**3 HISTORY**

PHU\_MB\_SCH\_V0.1 [yangxutao 2019/09/09]

PHU\_MB\_SCH\_V3.0 [yangxutao 2020/06/05]

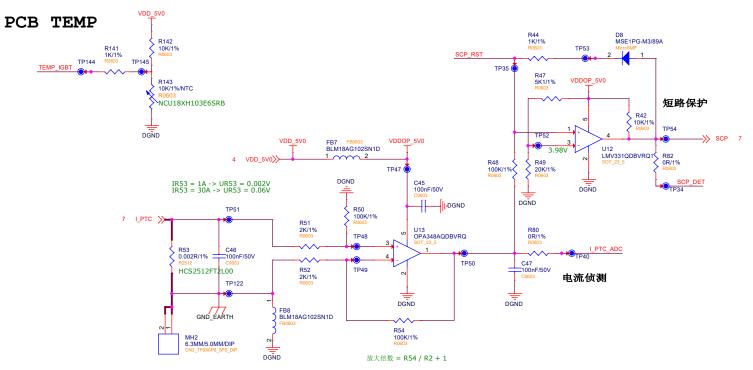
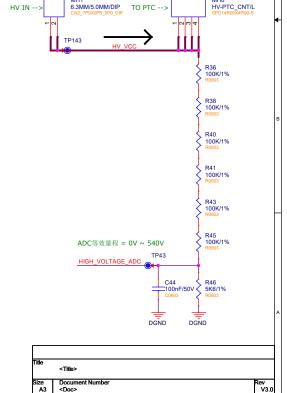
- 1.Q5、Q7和Q9需要连接至Q11、Q13和Q15的GATE极,以防止产生保护时短路IGBT VCC; [P7]
- 2.信号IGBT PWM0/IGBT PWM1/IGBT PWM2需要增加限流电阻R138、R139、R140 1K/5%,以防止产生保护时短路VDD 5V0; [P7]
- 3.Q10、Q12、Q14、Q16、Q17、Q18物料由BSS84更换为DMP4065SQ, 新物料符合AEC-Q100认证; [P4,P7]
- 4.增加板上NTC温度传感器R143,连接至U7单片机的6脚,以测量IGBT的温度; [P6]
- 5.删除外部温度传感器电路; [P4,P5]
- 6.02型号KST42MTF已经停产,更换物料为SMMBTA42LT1G,封装和参数一致替代料;[P4]
- 7.U21物料由B0512XT-1WR2更换为B0512XT-1WR3, V0.1版本中实际贴片物料型号为B0512XT-1WR3, B0512XT-1WR3为最新版本,旧版本已经采购不到物料; [P4]
- 8.主MCU和从MCU的调试接口信号增加ESD二极管D16、D17、D18、D19、D20和D21,以防止调试时静电损坏MCU; [P5,P6]
- 9. 删除D7和D13二极管,因此二极管与MCU不能实现快速放电,会使MCU无法烧录程序; [P5, P6]
- 10.NC掉MCU的复位电容C27和C40,以防止MCU不能上电复位。Microship规格书要求烧录器调试时使用复位电容,调试完后NC掉; [P5,P6]
